DESIGN REVIEW TECHNICAL ADVISORY COMMITTEE MEETING
November 1, 2016 | 4:00 P.M.
Five Seasons Conference Room
City Services Center | 500 15th Avenue SW
AGENDA

DESIGN REVIEW TECHNICAL ADVISORY COMMITTEE STAFF REPORT

Date: November 1, 2016
Applicant: City of Cedar Rapids
Owner: City of Cedar Rapids
Location: Lot 44 & Sinclair Site
Request: Façade & Site Plan Review
Date Application Received: October 31, 2016

IOWA RIVER BASIN
CEDAR RIVER
CEDAR RAPIDS, IOWA
FLOOD RISK CONTROL SYSTEM PROJECT
NEWBO / PARKING LOT 44 PUMP STATION
BUILDING ELEVATIONS

#4 Awning

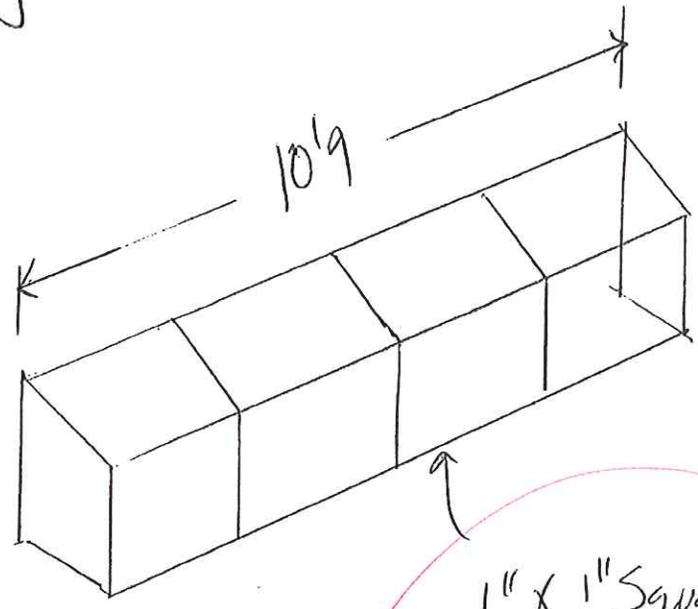
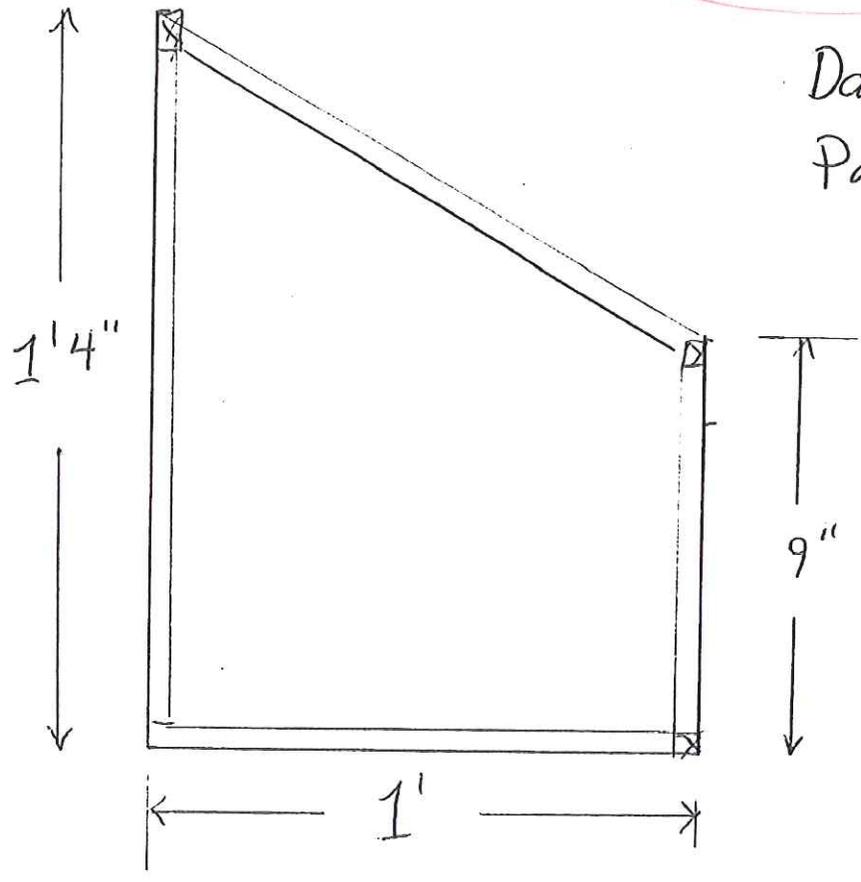
Sign permit required

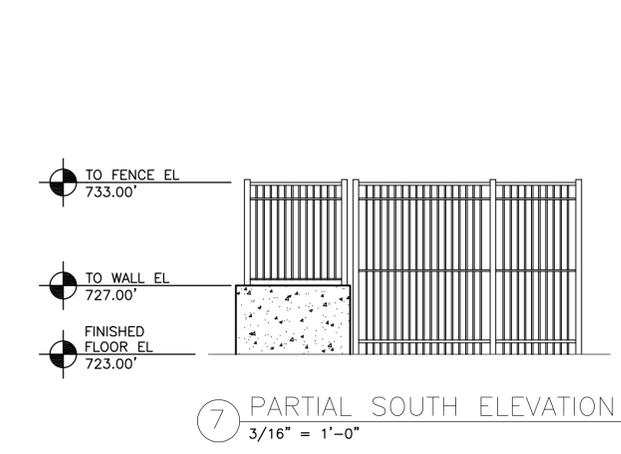
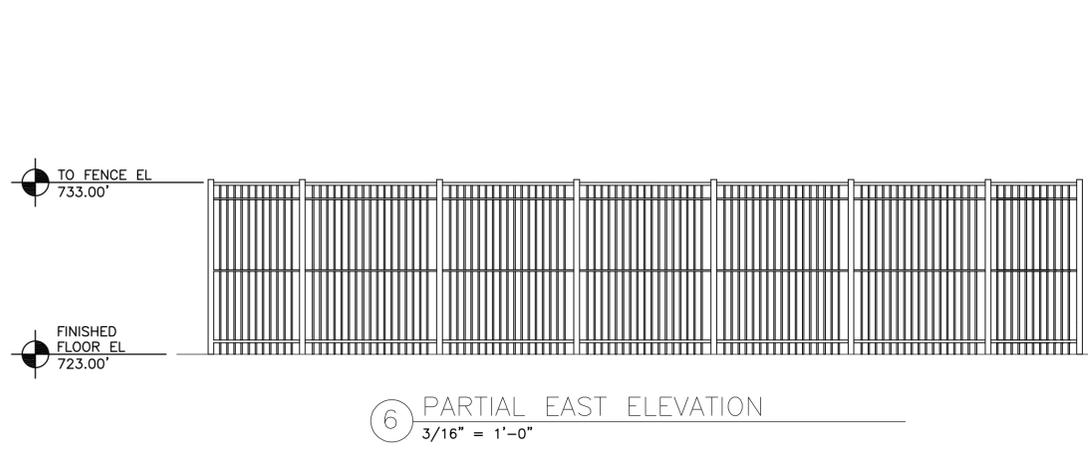
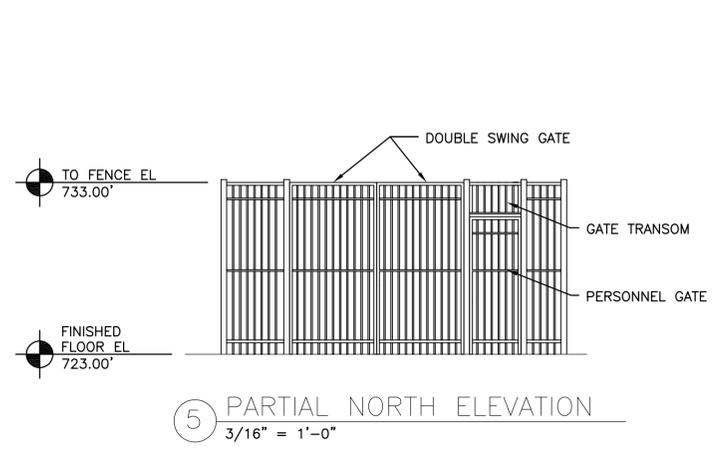
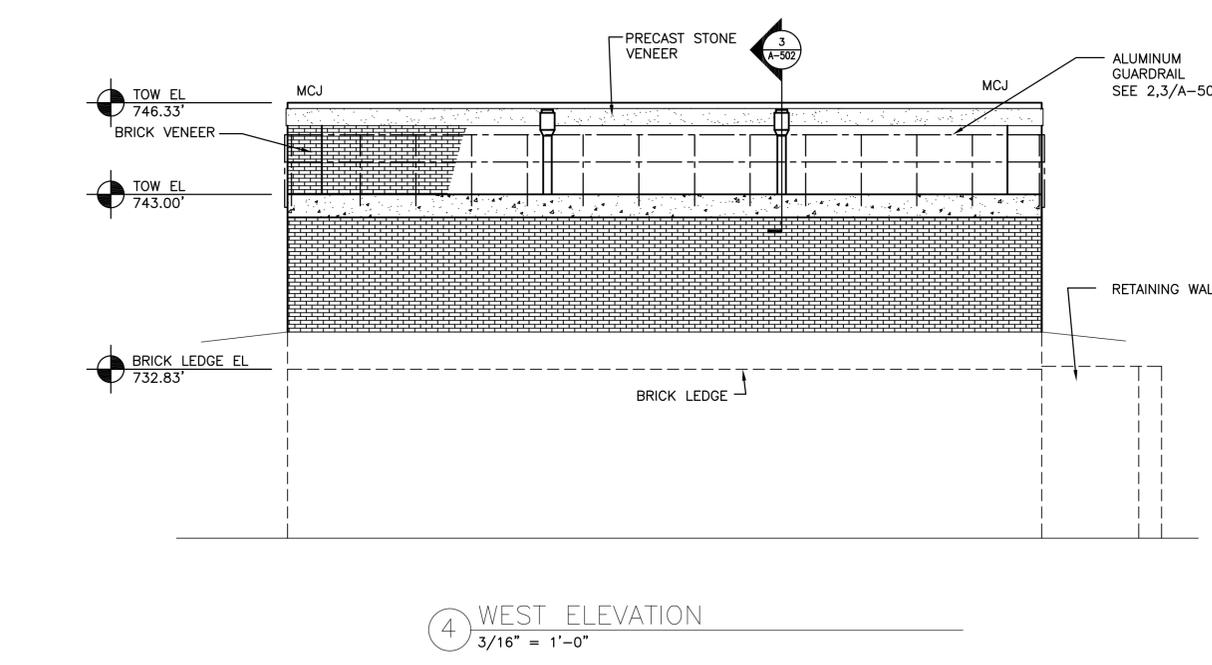
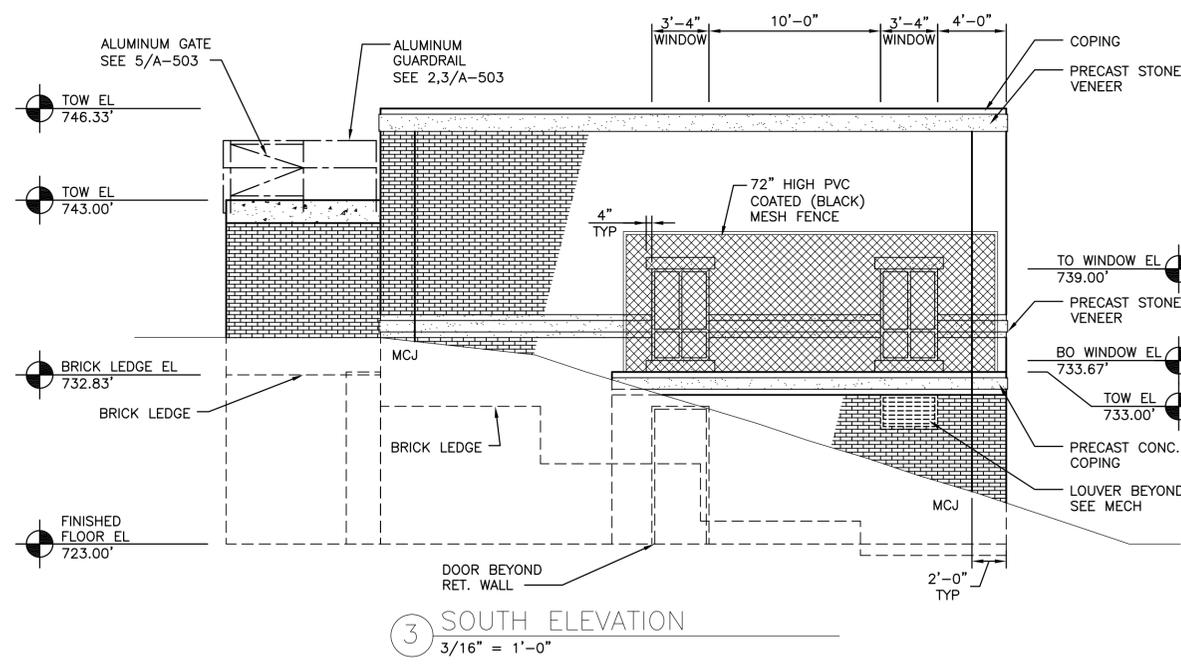
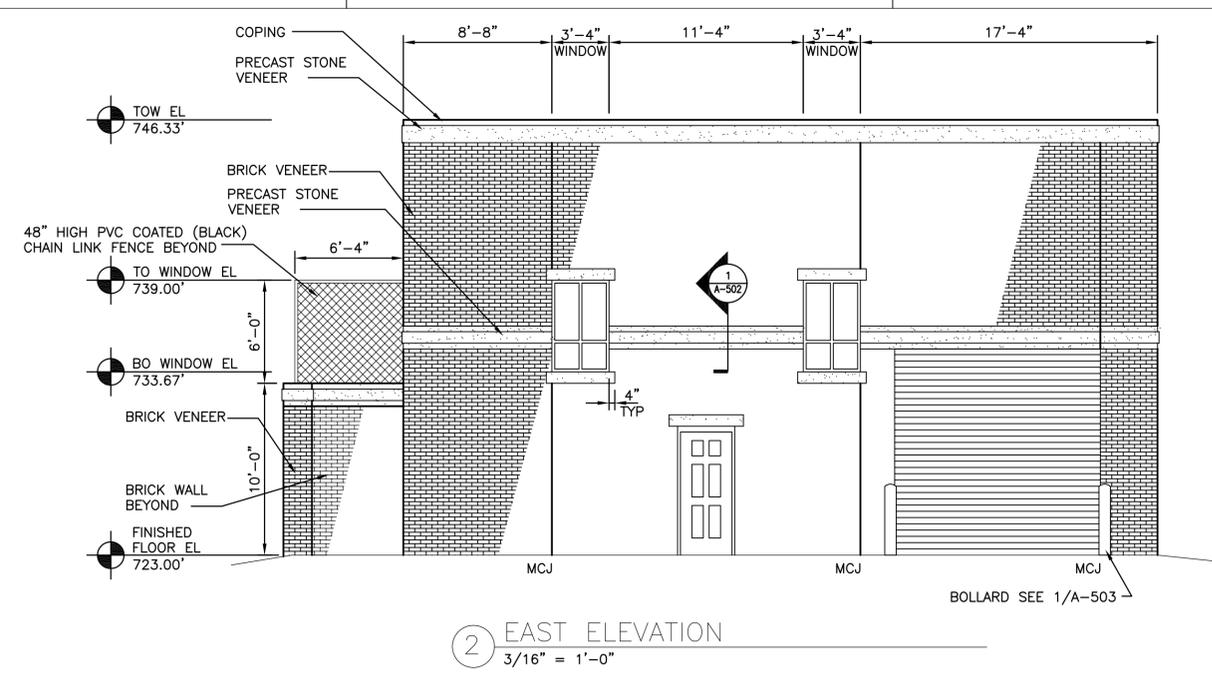
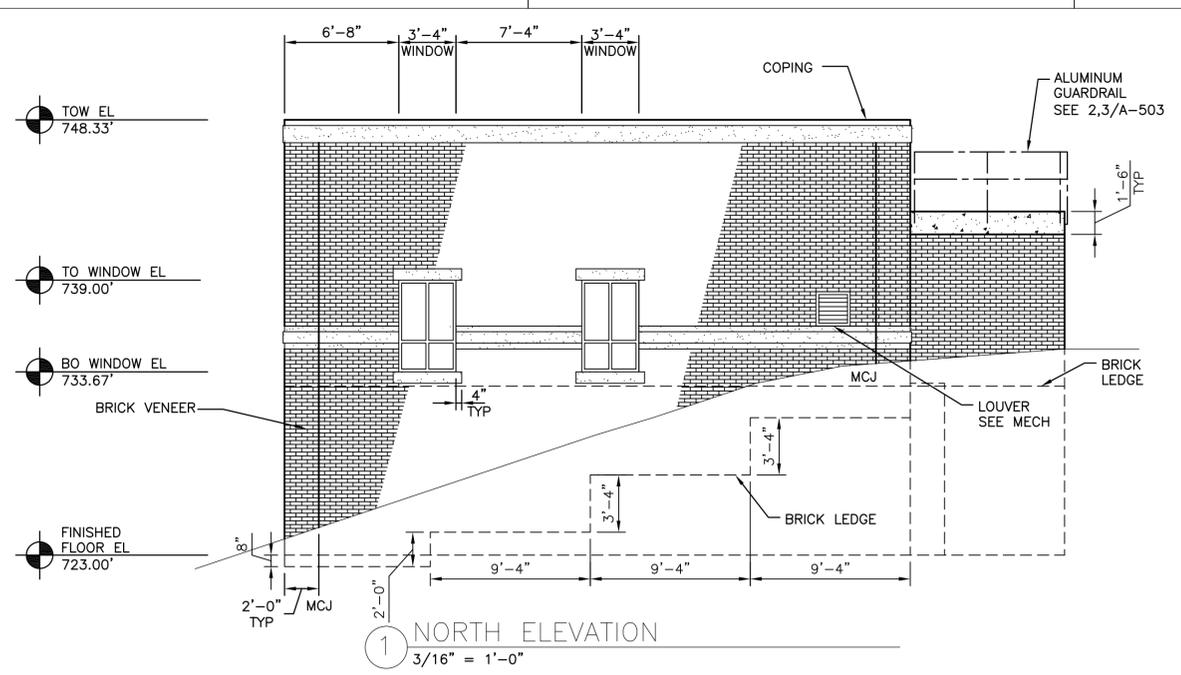
Lot 44 Pump station

- This should be called the New Bohemia Pump Station as opposed to lot 44 pump station or 10th Avenue pump station or whatever else
- Match the brick color and general size of the brick look to that of the Czech school (the historic part, not the later box style additions to it)

- The mortar between the bricks should not be bright white, but should have less contrast with the bricks (use dark mortar)
- Ensure the generator is elevated or on some type of pad in case water rises

- One rendering showed a belt course in the middle of the building all the way around and the rendering showed a skirting of a limestone looking material. The commission thinks both should be included.

- Limestone color on the trim (skirting, belt course and parapet), but it doesn't necessarily need to be limestone, some substitute material would be ok

- Regarding the wrought iron fencing around the generator on the outside of the building, if the brick wall could be continued to conceal the generator more than would be preferred. Some sort of taller landscaping would also be ok with the commission if the wrought iron fence is to remain as shown.

SINGLAIR LEVEE
PUMP STATION & DETENTION BASIN
ELEVATIONS, SECTION, AND DETAILS

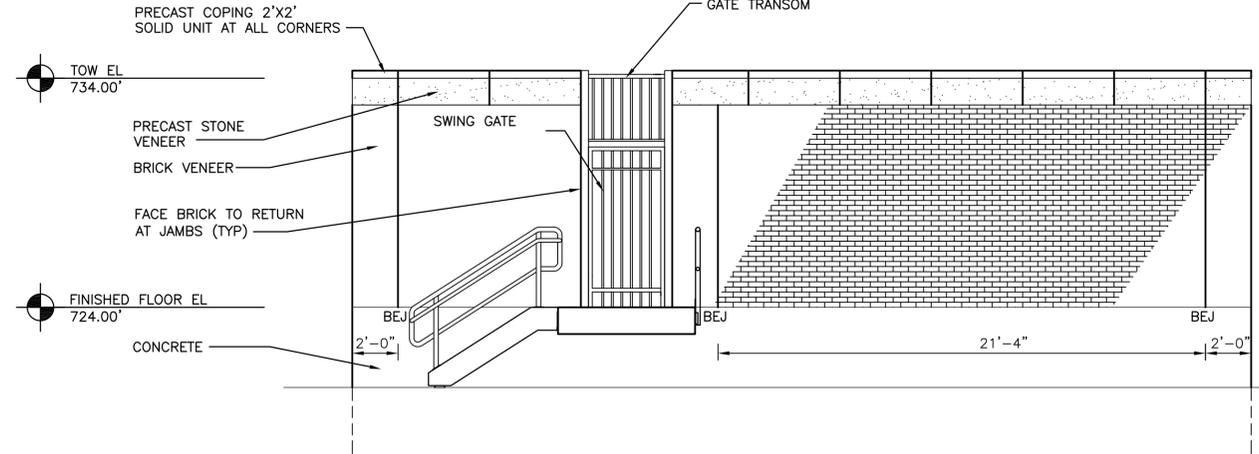
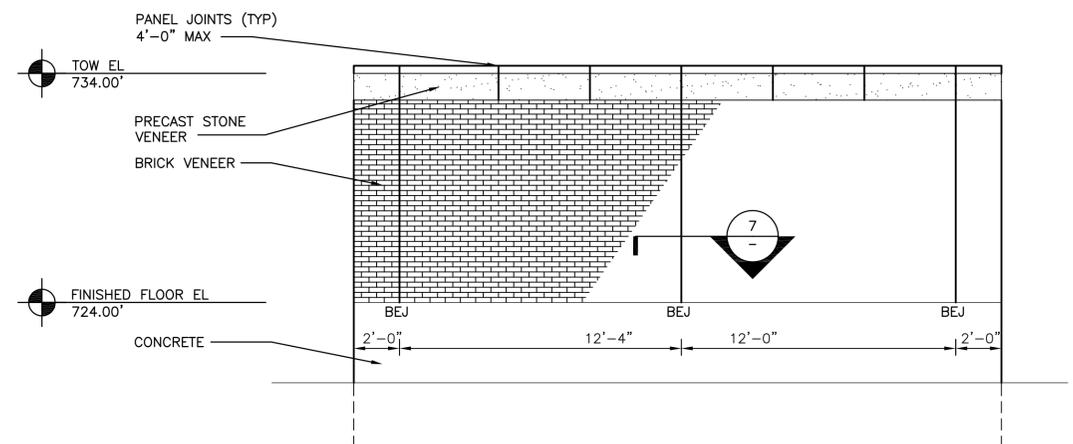
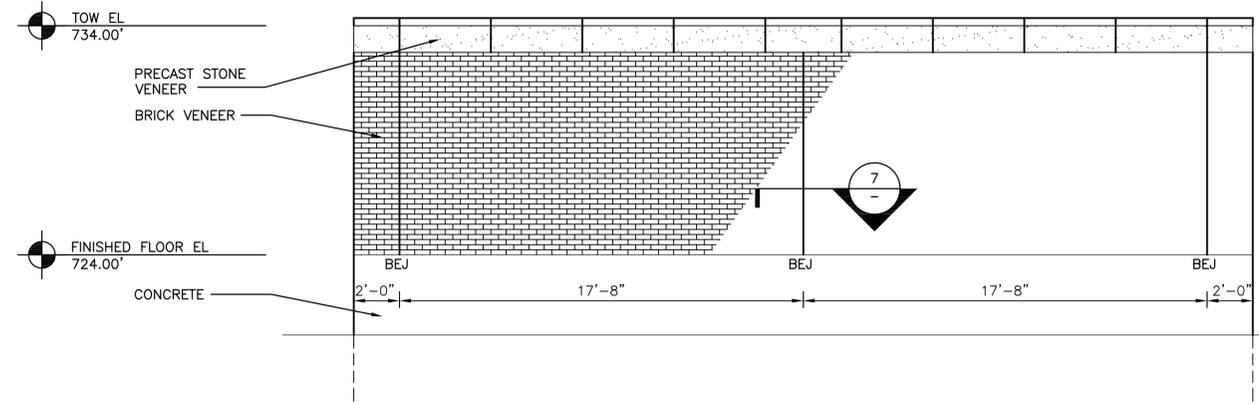
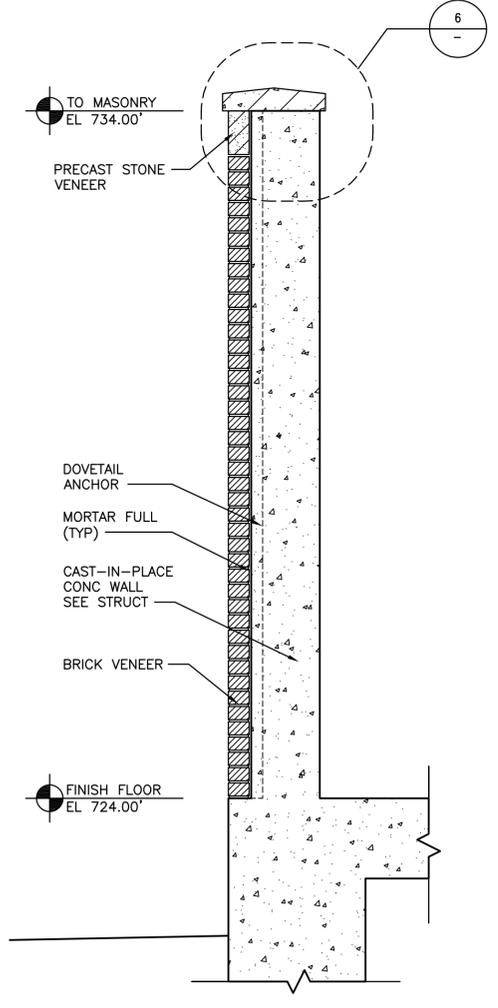
Sinclair Pump Station

- The trees which conceal the station should be as tall as practically possible, evergreens

are a good choice.

- They like this name since it pay homage to the former Sinclair Plant on the site.
